Contract #: 04-0120F4Cty: SF/ALA Rte: 80 PM: 13.2/13.9File #: 69.25B**QUALITY ASSURANCE -- NON-CONFORMANCE REPORT****Location:** Changxing Island, Shanghai, P.R. China**Report No:** NCR-000754**Prime Contractor:** American Bridge/Fluor Enterprises, a JV**Date:** 02-Jun-2010**Submitting Contractor:** Zhenhua Port Machinery Company, Ltd (ZPMC), Changxing Island**NCR #:** ZPMC-0717**Type of problem:**

Reference Description: QA found 3 MT Indications after the contractor's had tested and accepted the welds for Segment 10CW Corner Assembly Diaphragm to Edge Plate Stiffener

Job Name: SAS Superstructure

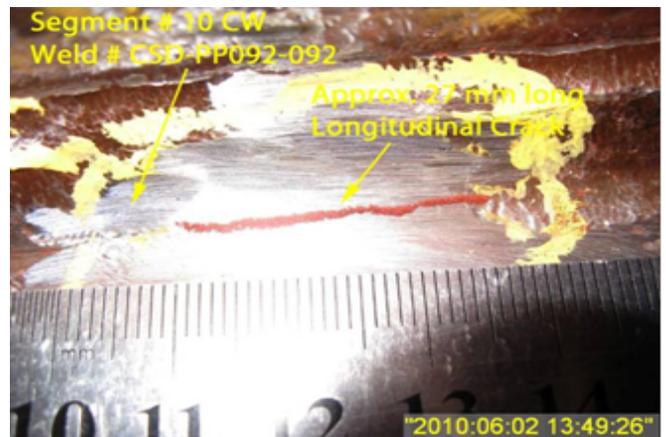
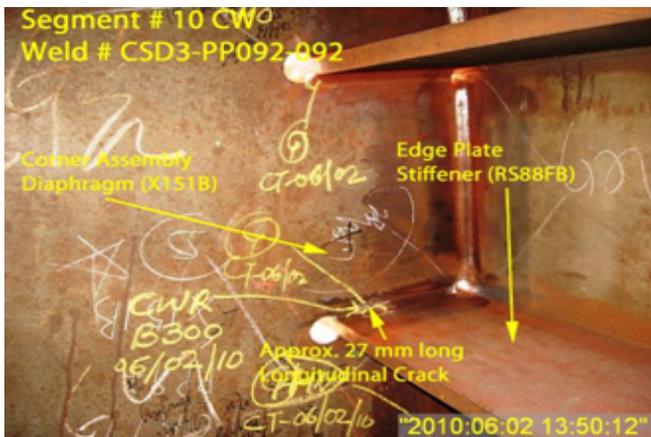
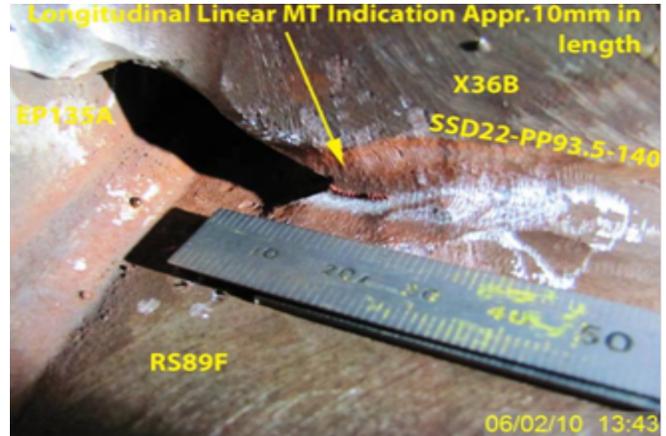
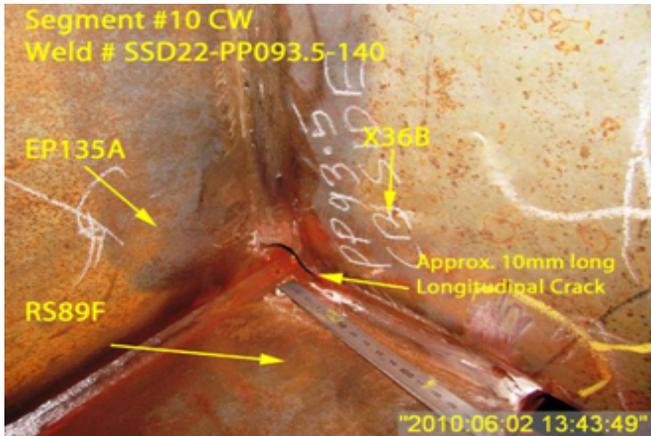
During the Quality Assurance (QA) Magnetic Particle Testing (MT) review of welds located on Segment 10CW, QA Inspectors discovered Three (3) Longitudinal Linear indications on the following welds:

- Weld #CSD3-PP092-092: One Longitudinal linear indication measuring approximately 27 mm in length.
- This weld is a Fillet Weld joining the Corner Assembly Diaphragm identified as X151B (SPCM) to Edge Plate Stiffener identified as RS88FB.
- The weld is designated as Seismic Performance Critical Material (SPCM).

- Weld #SSD22-PP093.5-140: One Longitudinal linear indication measuring approximately 12 mm in length.
- This weld is a Fillet Weld joining the Corner Assembly Diaphragm identified as X36B to Edge Plate Stiffener identified as RS89F.

- Weld #SSD22-PP093.5-144: One Longitudinal linear indication measuring approximately 9 mm in length.
- This weld is a Fillet Weld joining the Corner Assembly Diaphragm identified as X36B to Edge Plate Stiffener identified as RS89F.

- All indications are clearly marked on the material near the weld.
- OBG segment 10CW is located outside west of Bay#16.

ZPMC will provide NDT to show these welds are acceptable after the repairs are complete. Based on this proposal ZPMC requests that this NCR be approved, with actions pending.

This proposed resolution is accepted, action pending. Please provide NDT results for these welds upon completion of the repairs.

ZPMC has repaired the indications and is providing NDT to show that the weld is acceptable. ZPMC has written and internal NCR. In addition, ABFJV and ZPMC's QA Manager are having a meeting to discuss the issues of missed indications in the OBG and determine a better way to prevent the missed indications. Please note the weld IDs referenced in the NCR were incorrect and the relevant reports ZPMC is providing show the correct weld IDs. Based on this ZPMC requests closure of this NCR.

This proposed resolution is acceptable. The documentation received is sufficient and the Department concurs that Non-Conformance ZPMC-0717 is closed.

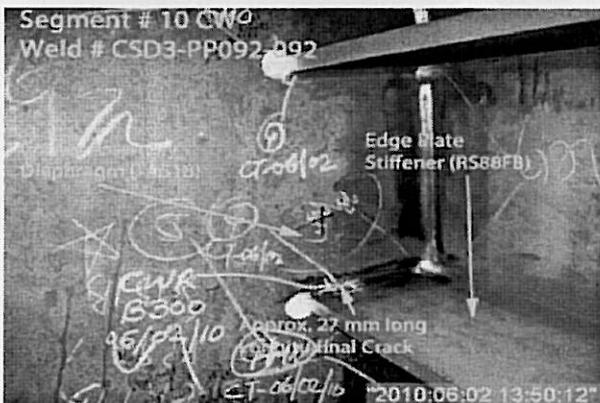
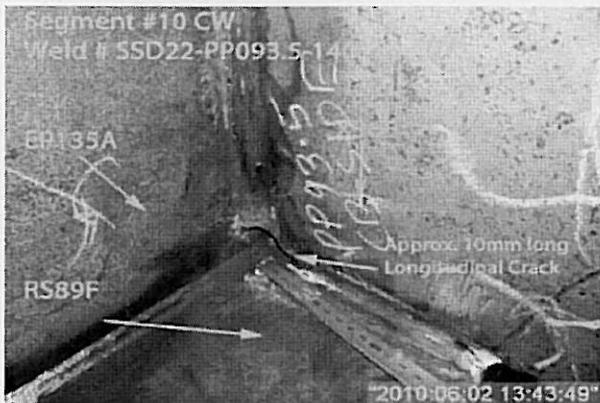
During the Quality Assurance (QA) Magnetic Particle Testing (MT) review of welds located on Segment 10CW, QA Inspectors discovered Three (3) Longitudinal Linear indications on the following welds:

-Weld #CSD3-PP092-092: One Longitudinal linear indication measuring approximately 27 mm in length.

-This weld is a Fillet Weld joining the Corner Assembly Diaphragm identified as X151B (SPCM) to Edge Plate Stiffener identified as RS88FB.

-Weld #SSD22-PP093.5-140: One Longitudinal linear indication measuring approximately 12 mm in length.

-This weld is a Fillet Weld joining the Corner Assembly Diaphragm identified as X36B to Edge Plate Stiffener identified as RS89F.

-Weld #SSD22-PP093.5-144: One Longitudinal linear indication measuring approximately 9 mm in length.

-This weld is a Fillet Weld joining the Corner Assembly Diaphragm identified as X36B to Edge Plate Stiffener identified as RS89F.

-All indications are clearly marked on the material near the weld.

Repair said indication and perform NDT required to verify weld quality.
